**UNITED STATES PATENT AND TRADEMARK OFFICE**

10/763,658

# Office Action Summary

### **Claim Rejections – 35 U.S.C. 102**

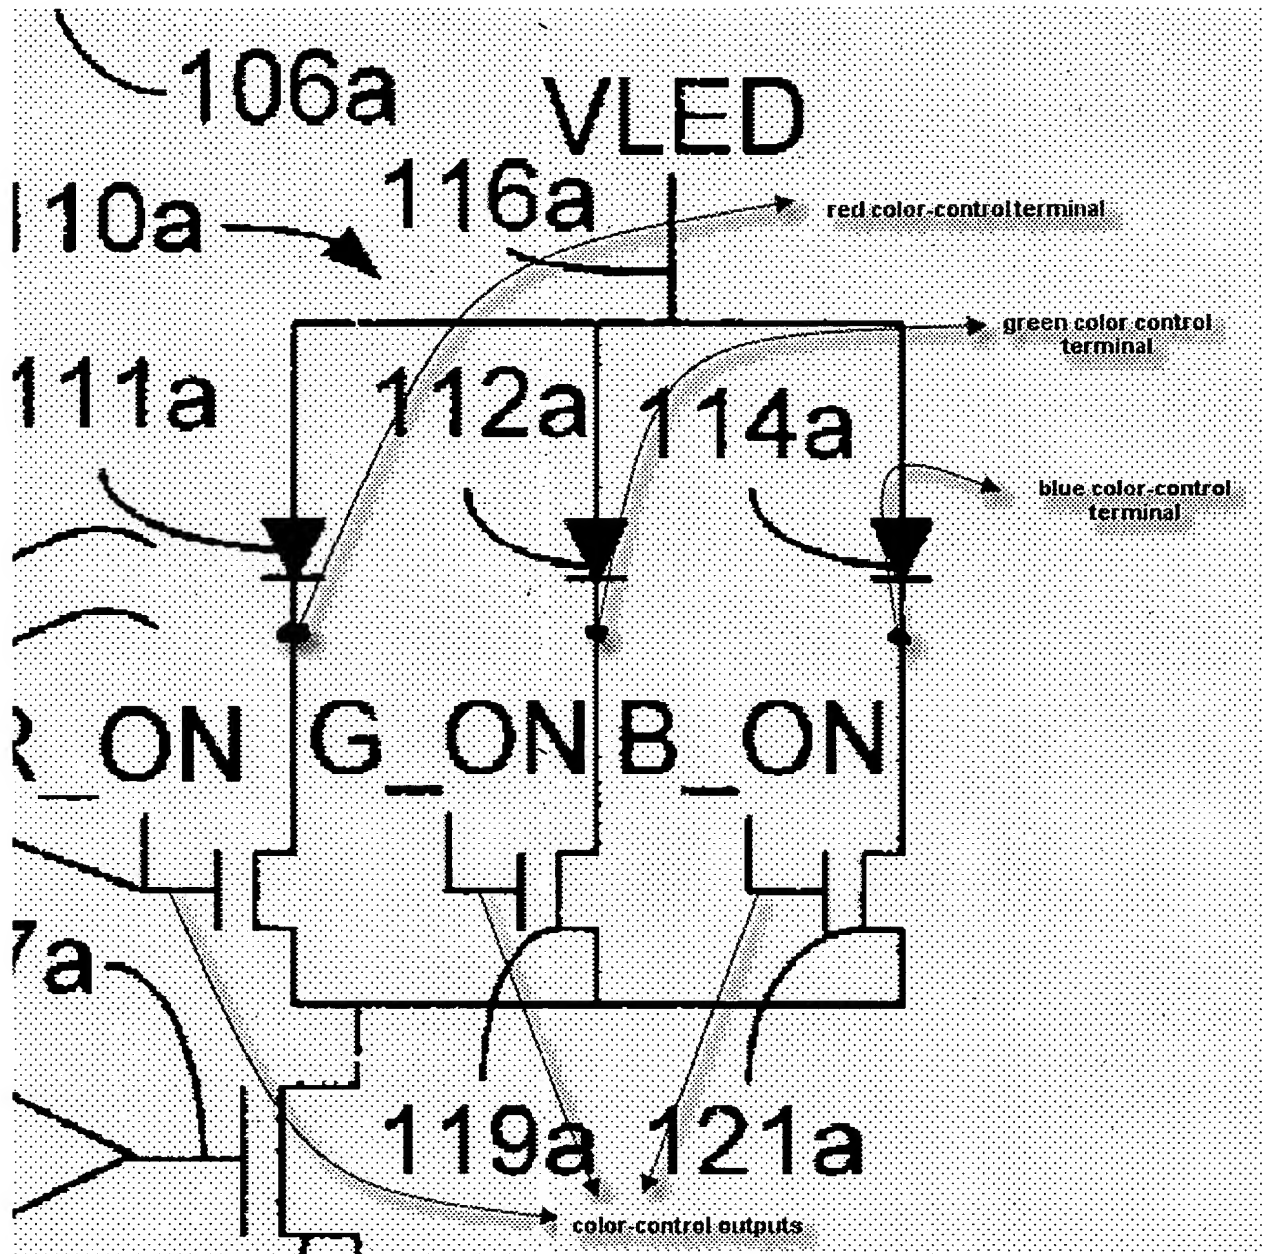
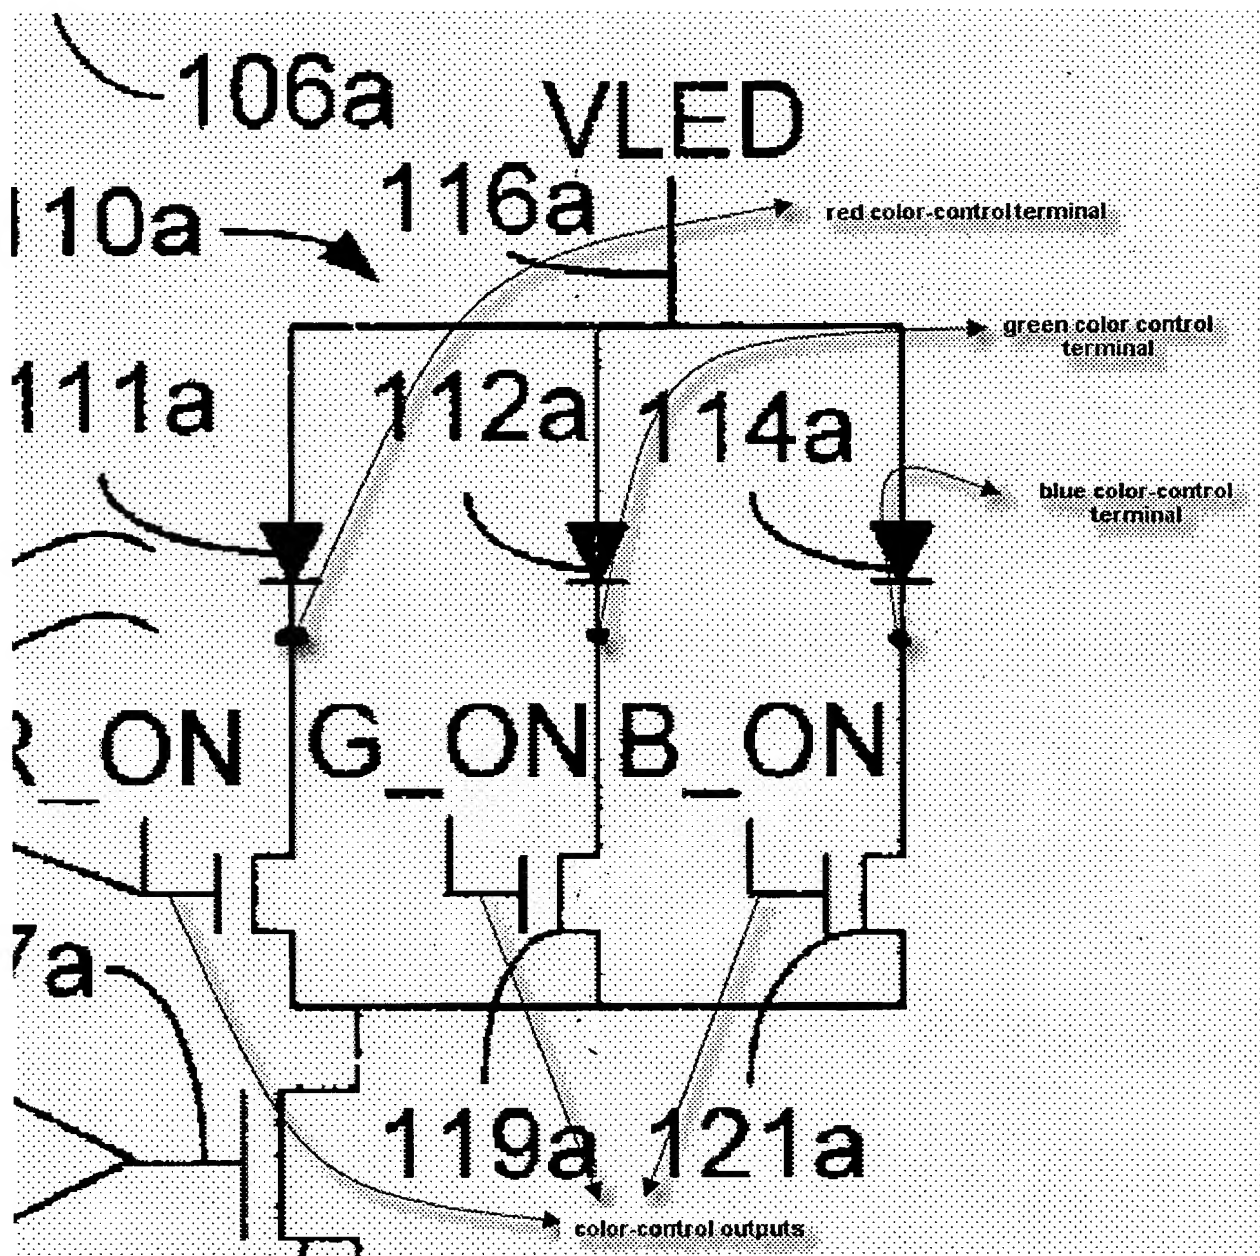
Regarding Claim 1, Blalock discloses a decorative lighting apparatus comprising

- control circuitry;
- a plurality of color-control outputs (labeled) from the control circuitry for coupling to color-control terminals (gates of 118a, 119a, 121a) of each one of a plurality of color-controllable lights (111a, 112a, 114a and 111b, 112b, 114b);

- the color-control outputs including a red color-control output (that coupled to 111a) for coupling to each red color-control terminal of the color-controllable lights;
- the color-control outputs including a green color-control output (that coupled to 112a) for coupling to each green color-control terminal of the color-controllable lights;
- the color-control outputs including a blue color-control output (that coupled to 114a) or coupling to each blue color-control terminal of the color-controllable lights;

- one or more set selection outputs (87a, 87b) from the control circuitry for selectively and individually enabling (LED1\_On and LED2\_On) at least a first set of one or more of the color-controllable lights and a second set (111b, 112b, 114b) of one or more of the color-controllable lights; and

- the control circuitry being operative to illuminate the color-controllable lights with a color scheme by repeatedly time-multiplexing color-control signals (See Col. 8, lines 49-55, Col. 10, lines 1-9 and Col. 11, lines 9-19) at the red, the green and the blue color-control outputs (See Col. 9, lines 47-50) to the first and second sets of color-controllable lights with use of the one or more set selection outputs.
